November 22, 1999
Work Plan 0164.W4

Ms. Susan Hugo
Alameda County Department of Environmental Health
1131 Harbor Bay Parkway
Alameda, CA 94502

SUBJECT: MONITORING WELL DESTRUCTION AND INSTALLATION WORK PLAN
Hardage Construction, Incorporated Site
5800 Shellmound Street
Emeryville, CA

FIGURE 2
SITE PLAN DETAIL
Hardage Construction Corporation Site
5800 Shellmound Street
Emeryville, California

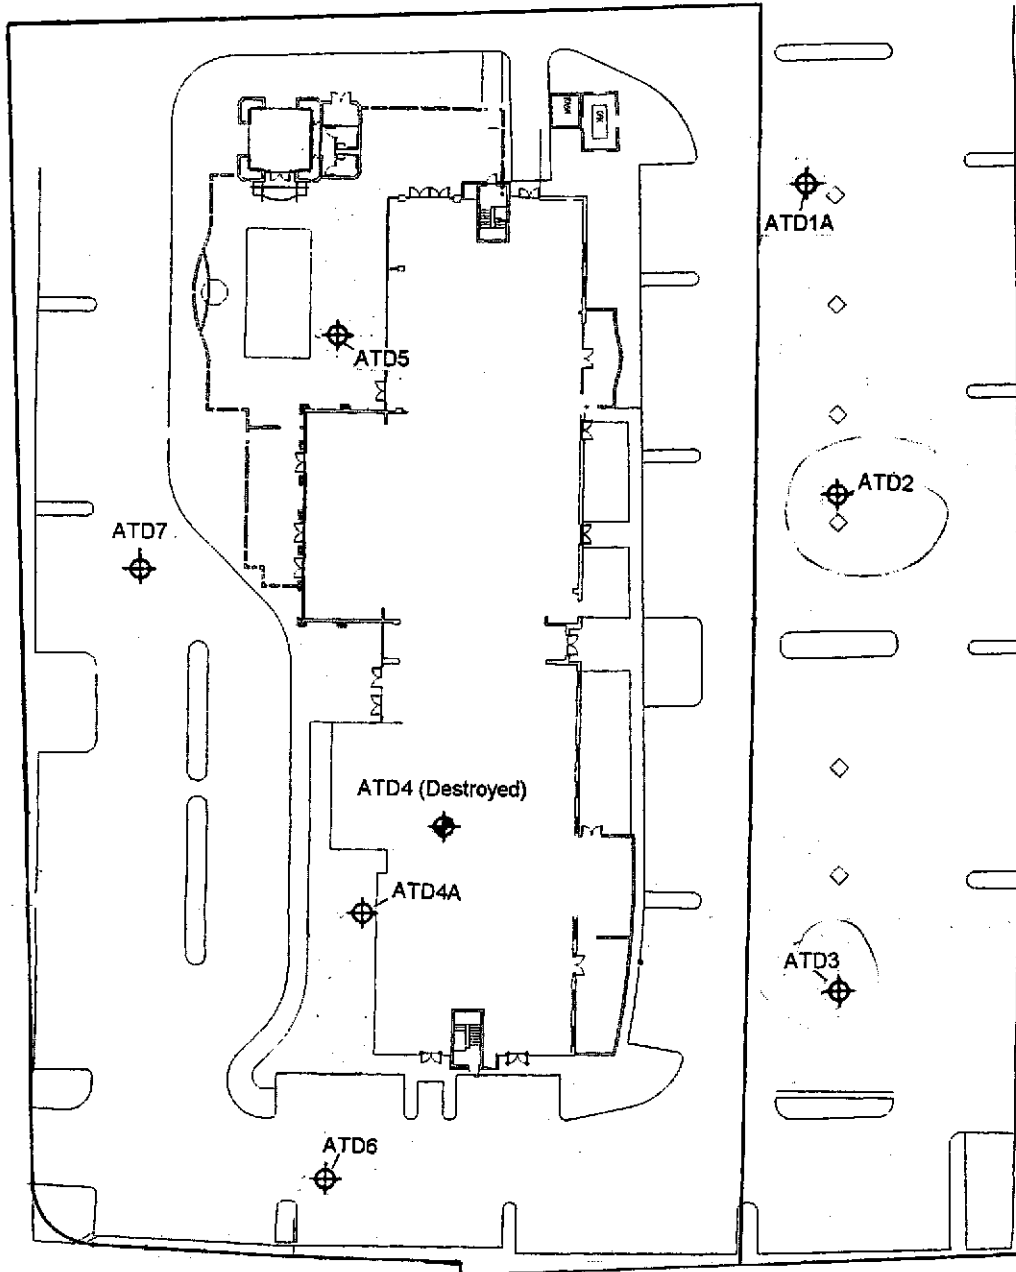
*11/29/99
1) Results of ATD2
monitoring
2) Why install in
the same area of ATD2*
